ADDENDUM No. 1

DATE: November 22, 2024

PROJECT: Village of Algonquin
Braewood Pump Station Rehabilitation

TAI PROJECT NUMBER: ALG-037

Braewood Pump Station Rehabilitation
Upper and Lower Level Process Plan
Algonquin, Kane County, Illinois

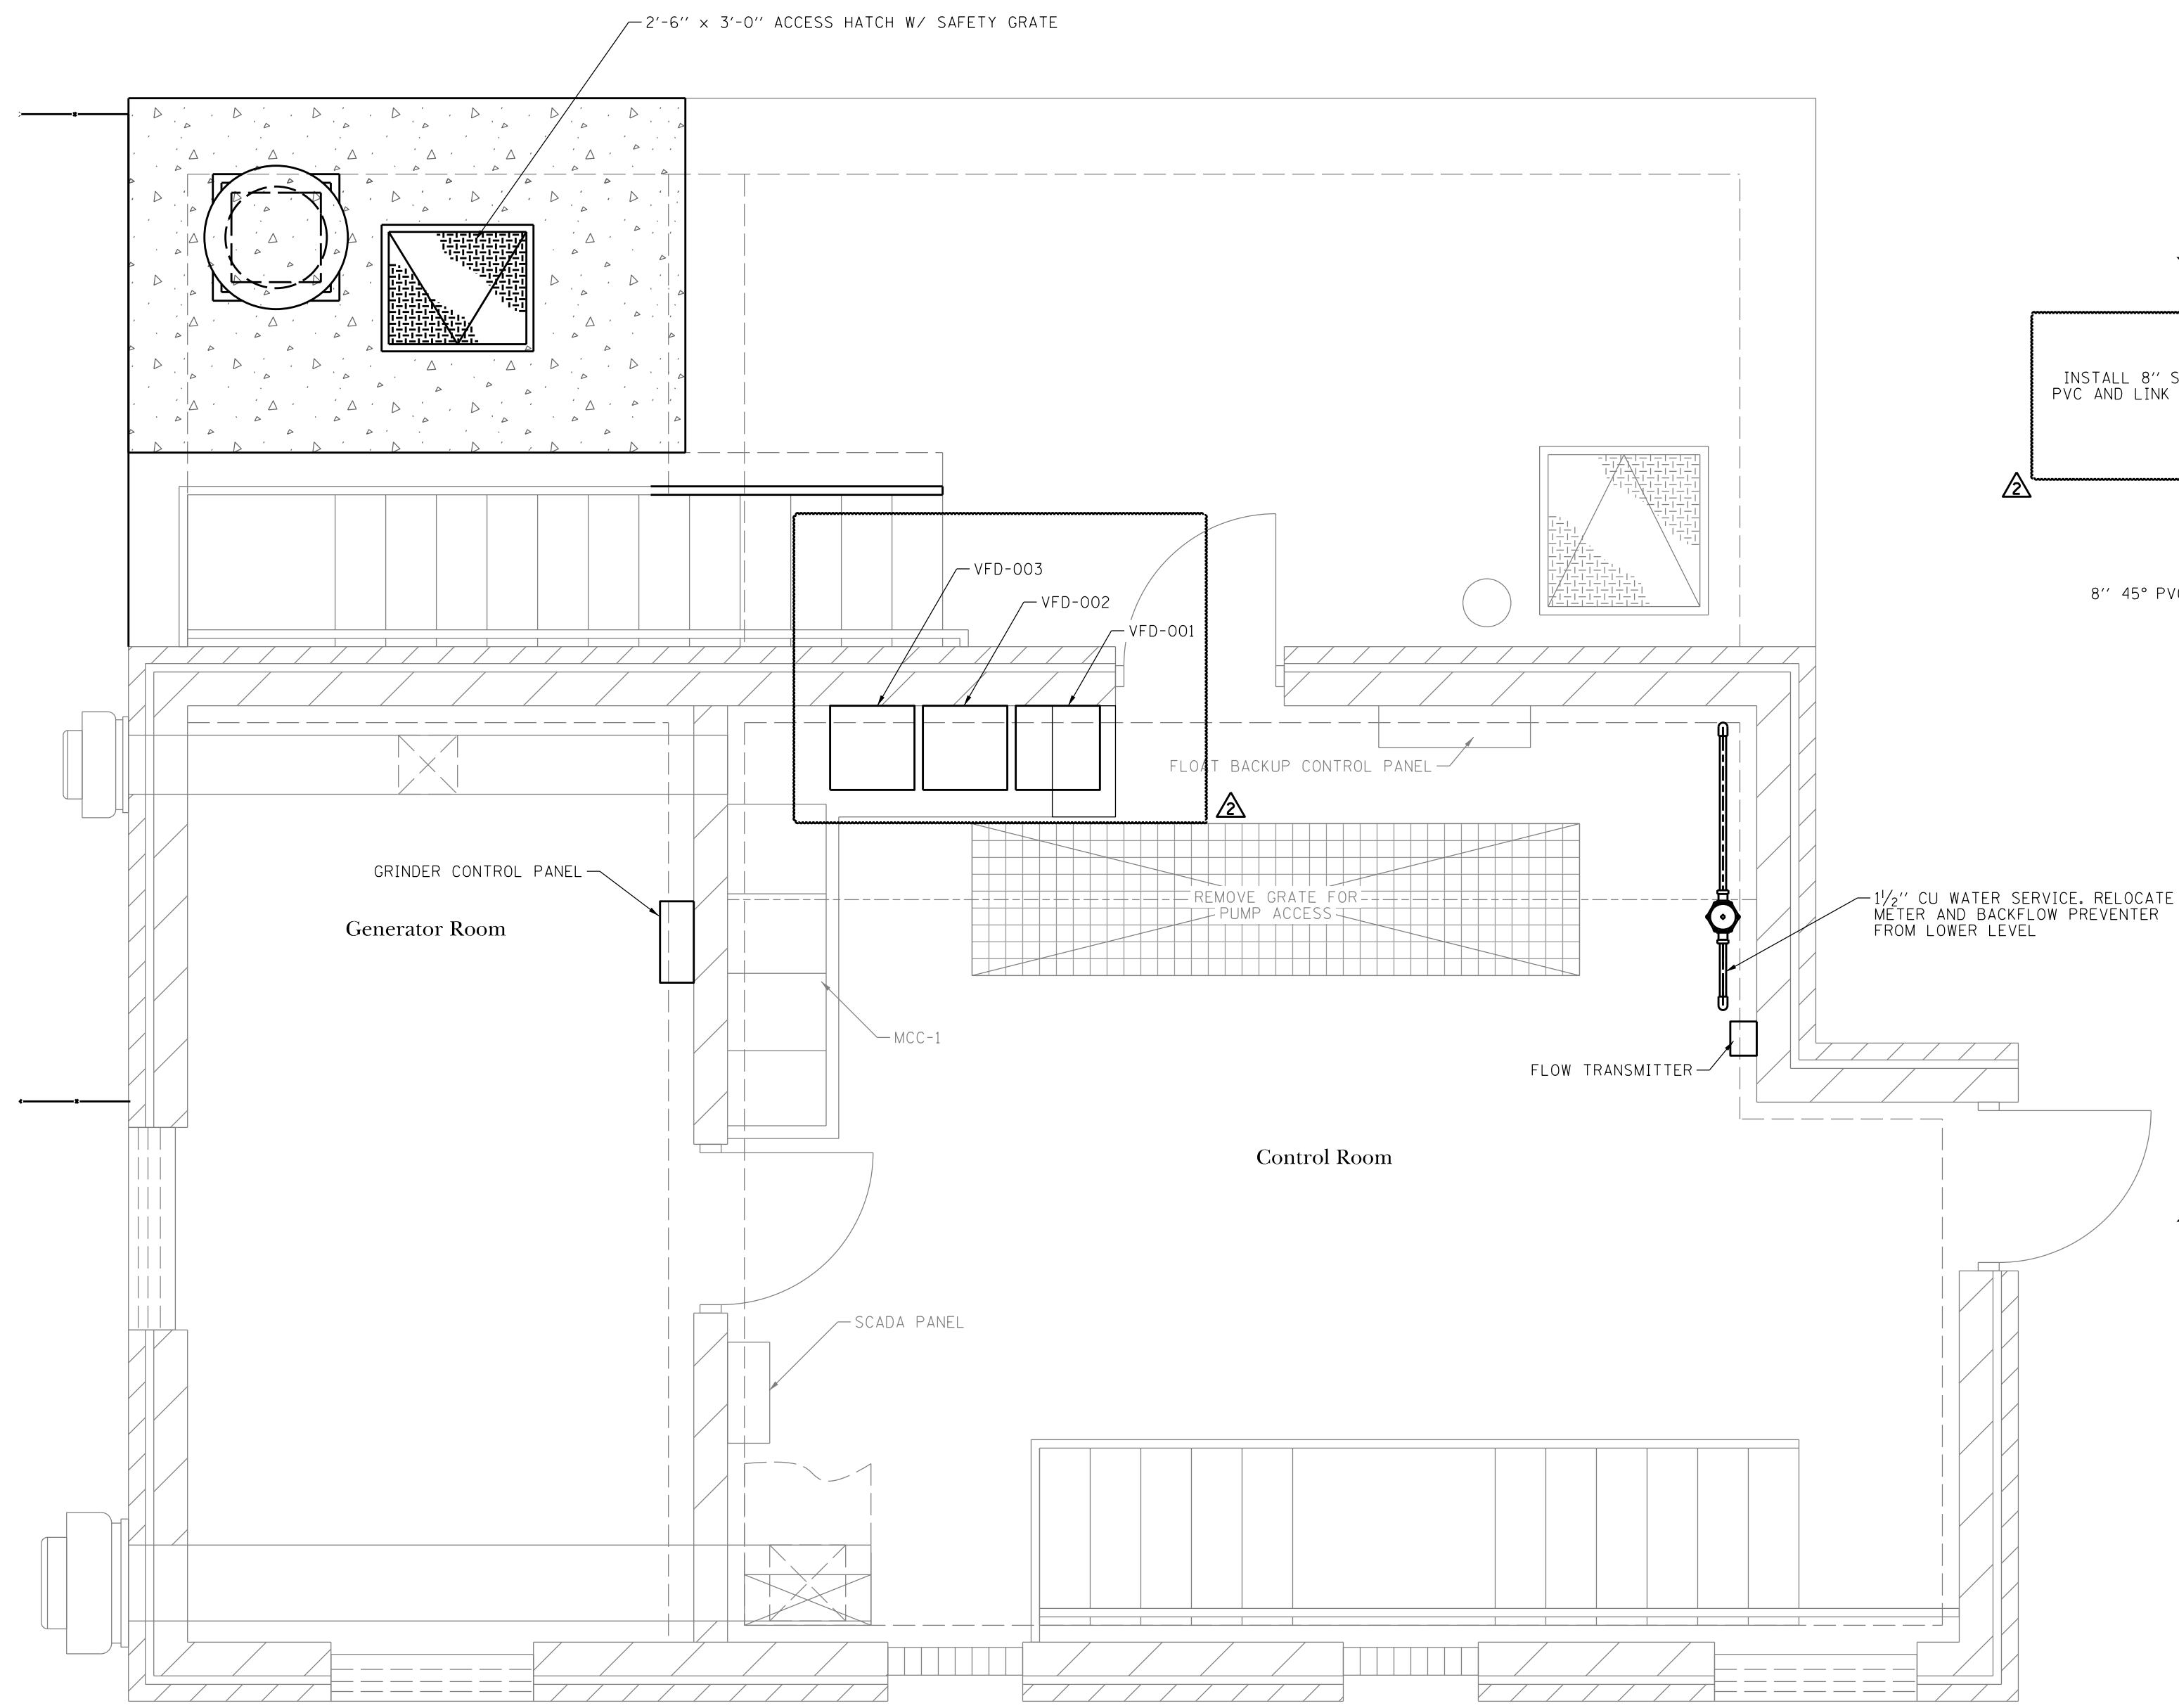
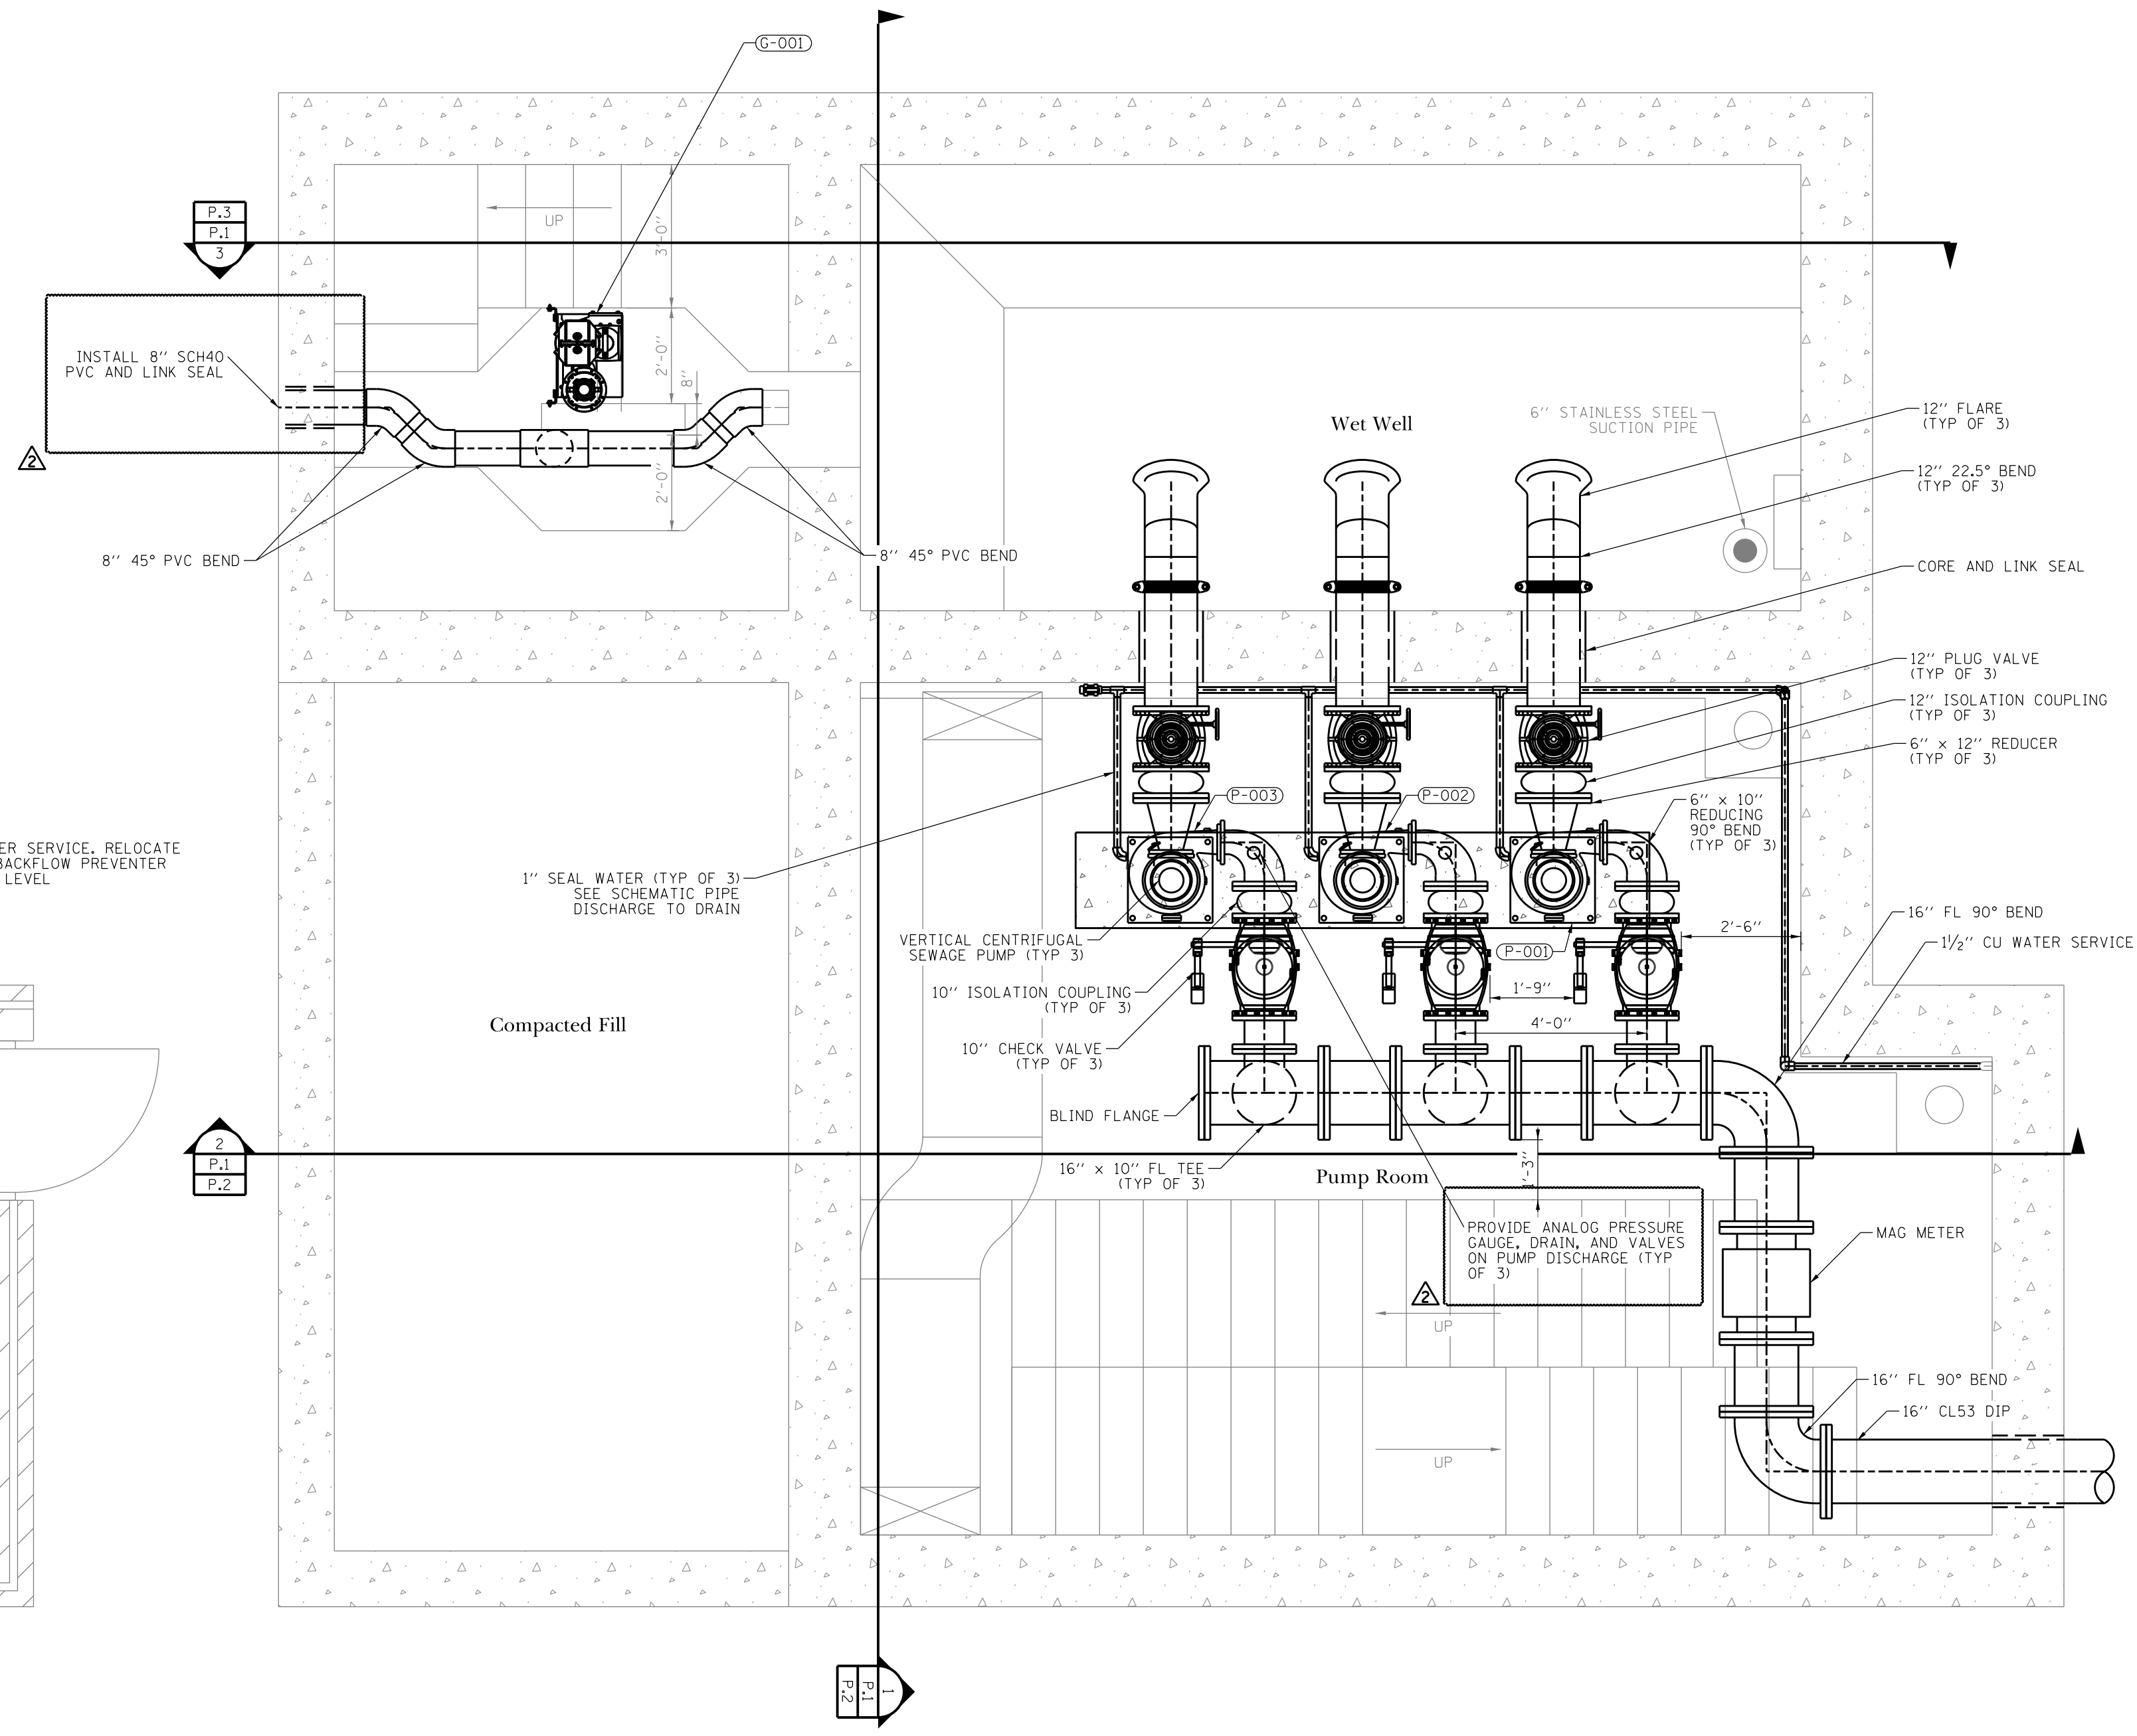
9. Sheet P.1 – Upper and Lower Level Process Plan

- A. Proposed odor control piping installation limits expanded.
- B. Note to install analog pressure gauges on pump discharge piping added.
